RE: **Site Source Control (SSC) Work Plan: Addendum No. 3**
Shallow Collection Trench East of the Stormwater Lagoon
General Motors Powertrain - Bedford Plant, Bedford, Indiana

This memorandum, submitted as SSC Work Plan: Addendum No. 3, provides the outline for the work to be conducted in the installation of the shallow collection trench east of the stormwater lagoon.

**GM BEDFORD REMOVAL ACTION
 SITE SOURCE CONTROL PLAN**
 ADDENDUM NO. 3
 AREA NORTH OF AO14
 COLLECTION SYSTEM 'H' SECTIONS

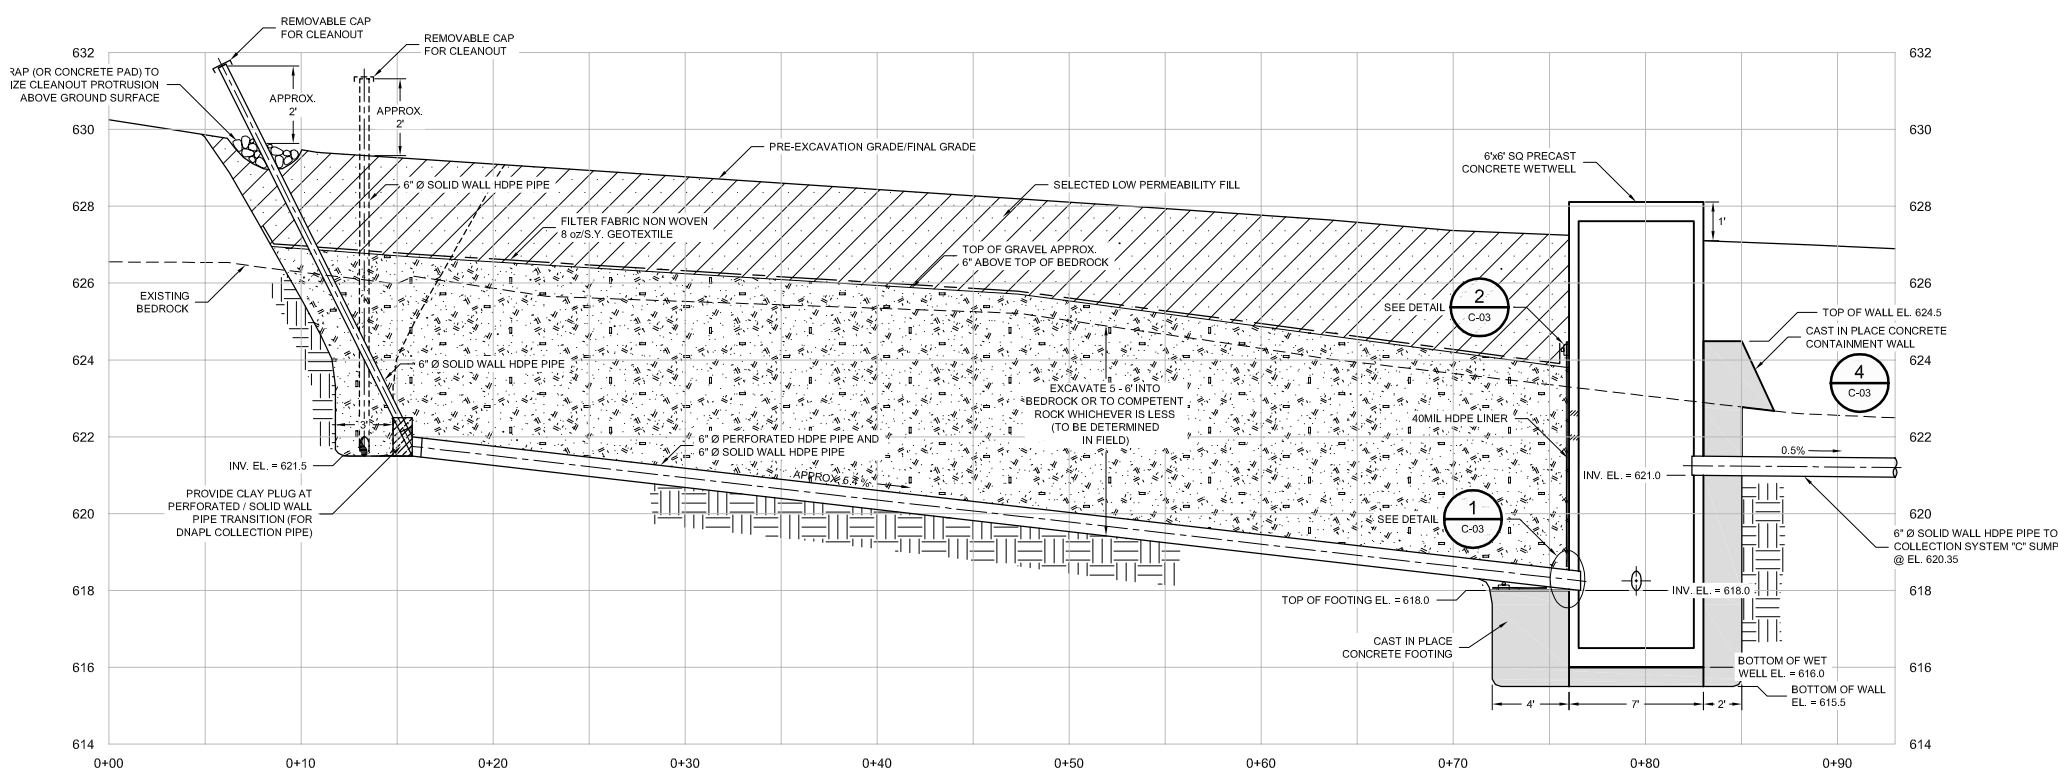
These drawings were developed as additional drawings to be added to the existing Site Source Control Drawing set. As discussed at our October 28, 2004 meeting at the Site, the design of this system is similar to the Parcel 3/205 design.
